Project: Alba Potline (6) and Power Plant (PS 5) Expansion

Addendum to Environmental and Social Impact Assessment Report

Document number: 3311003

Revision: E

Figure 1: Design Changes in Power Station 5

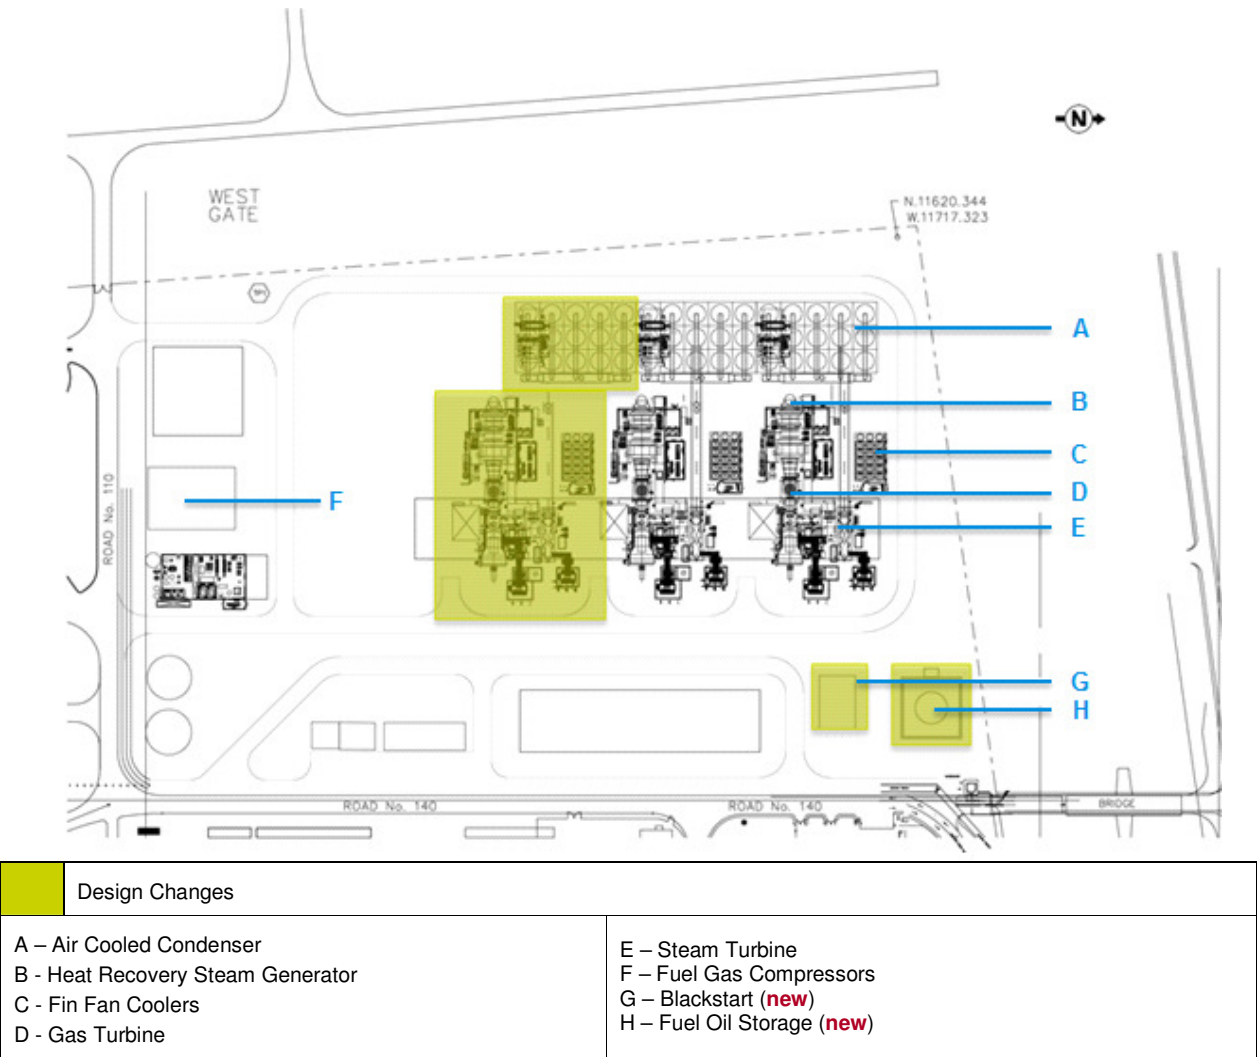
The initial design of PS 5, for which the ESIA was prepared, comprised two (2) F class units. In the current design change, an extra F class unit is added to the power station, hereafter referred to as PS-5C. Furthermore, the existing PS-2 will be shut-down and additional power² will no longer be sourced from the Electricity and Water Authority (EWA) grid.

- Additional F class unit for Power Station 5;
- Increased capacity of water storage tanks; and

- Addition of an extra oily water separator.

The above listed design changes are illustrated in **Figure 1**.

To provide a black start, diesel generators with a capacity of 18 to 22 MW will be used. These generators require the installation of a diesel storage tank (see **Figure 1**) with a storage capacity of 140 cubic metres (m³), sufficient for one day operation.
